**New Police Station**  
**Inuvik, NT**  
**Project Number: R.050563**  
**Addendum #2**  
**May 28, 2014**

**2.0 Architectural Addendum**

# Mechanical Addendum M-02

# Electrical Addendum E2

**ASK-06**

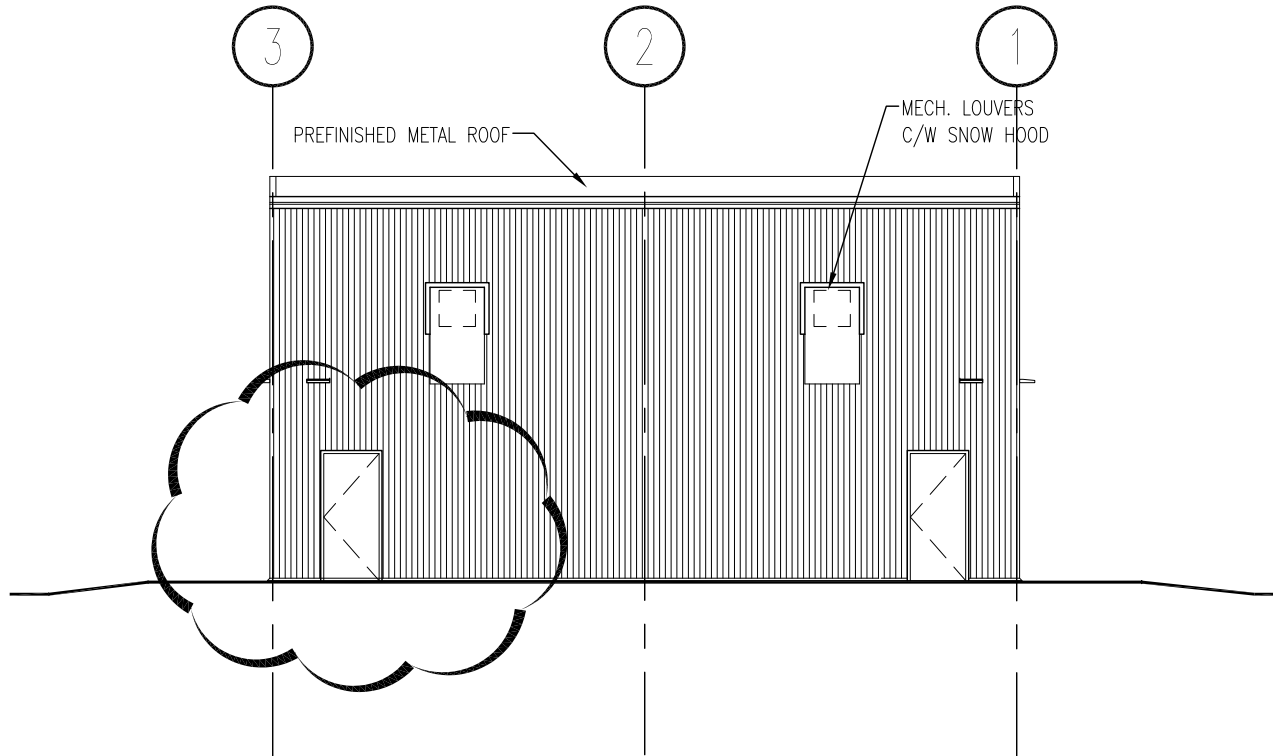
- .1 Refer to Drawing A0.4 – Outboard Garage (Pre-Engineered), Issued For Tender; Dated March 17, 2014.
  - .1 Add Door #D302A3 at the east corner of the building at Grid Line A3 as indicated on the appended Sketch Drawing ASK-06, prepared by IBI Group; dated May 22, 2014.

Scale:	N.T.S.	Date:	2014-05-22
Drawn by:	MC	Checked by:	EK
Project no.	R.050563	Sheet no.	ASK-07

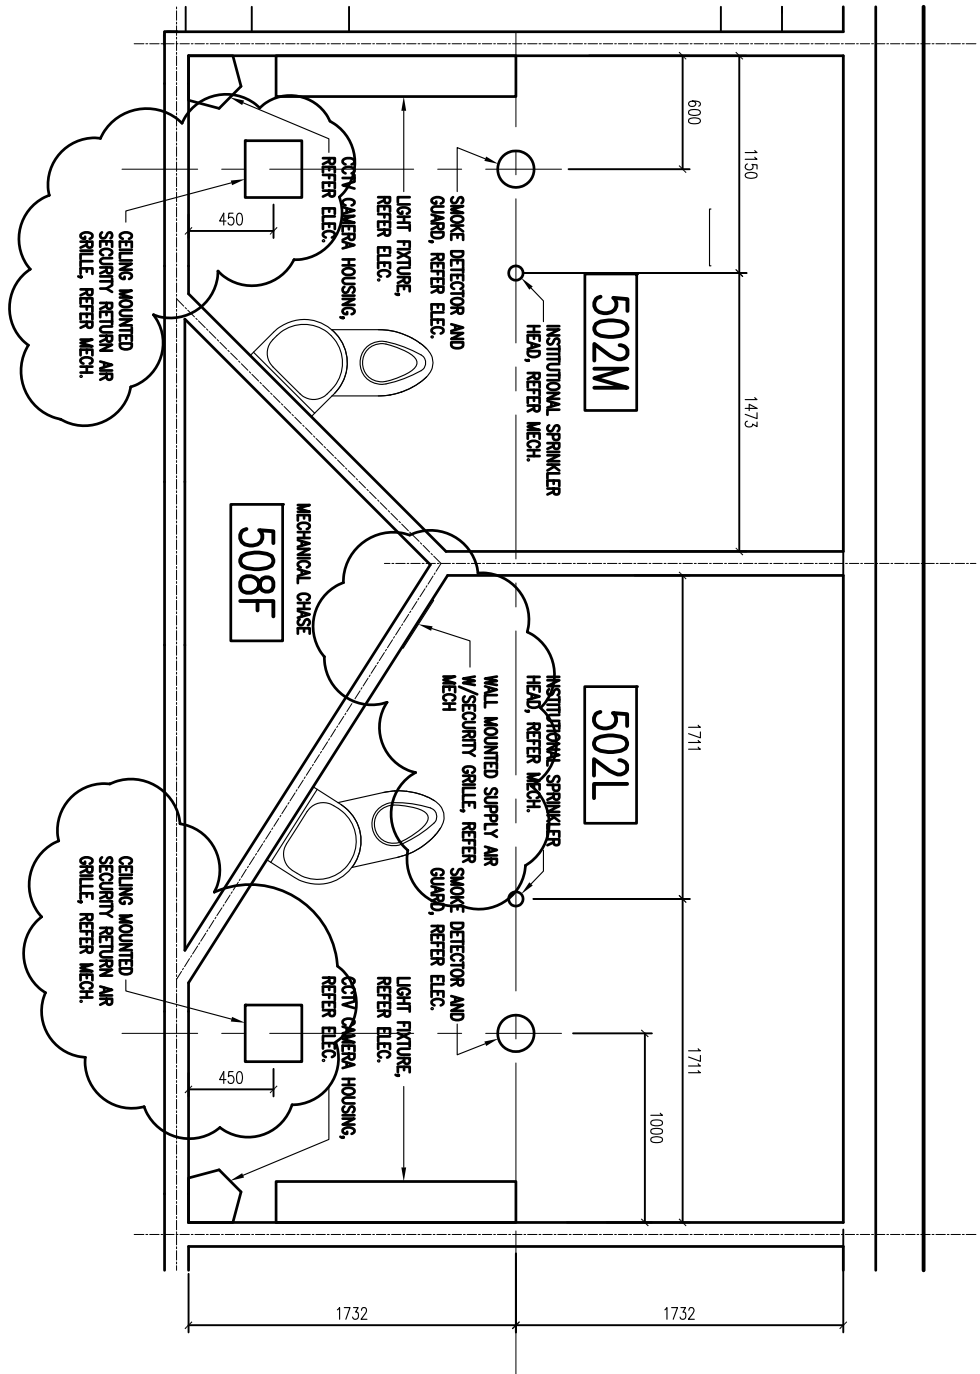
- .2 Revise the east elevation 5/A0.4 to add a new door at the east corner of the building as illustrated on the appended Sketch Drawing ASK-07, prepared by IBI Group; dated May 22, 2014.

PARTIAL PRINT OF E1.09 - ROOM 412

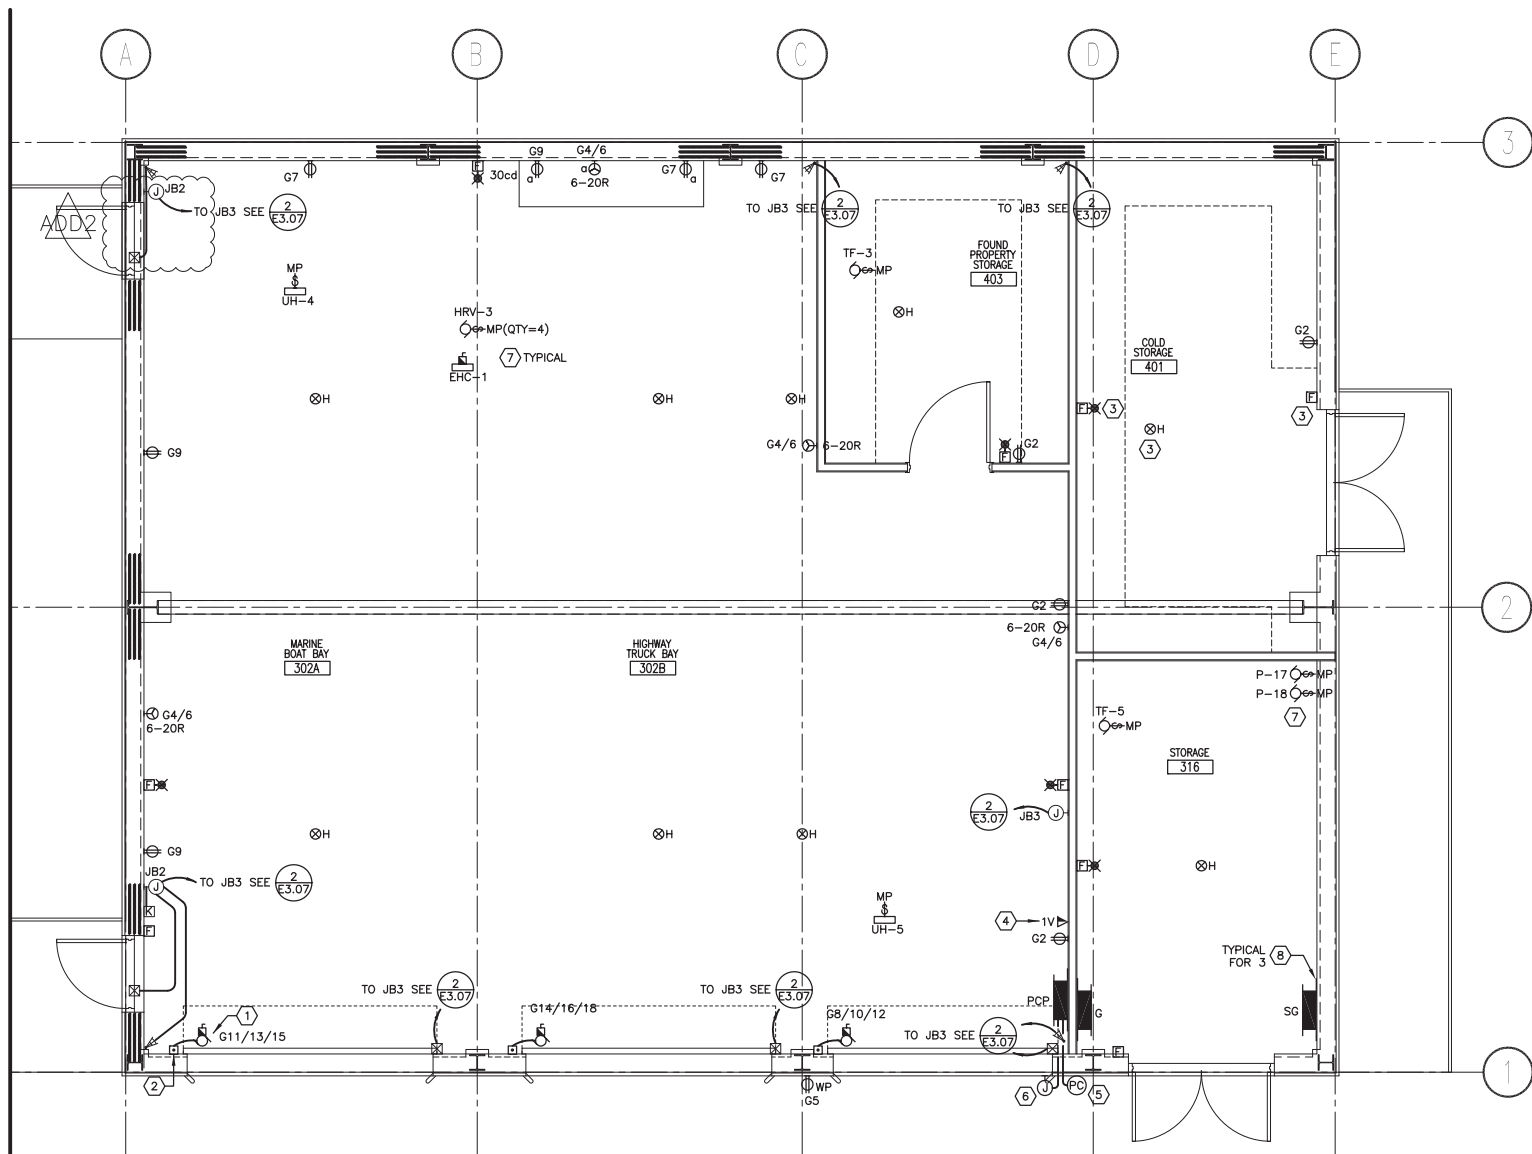
1. Drawing E1.09, Main Floor Fire Alarm and security Provisions Plan:  
Revise detector in room 412 as shown on the partial print of E1.09.  
Add detector in rooms 504, 508A to F and 513 as shown on the partial print of E1.09.
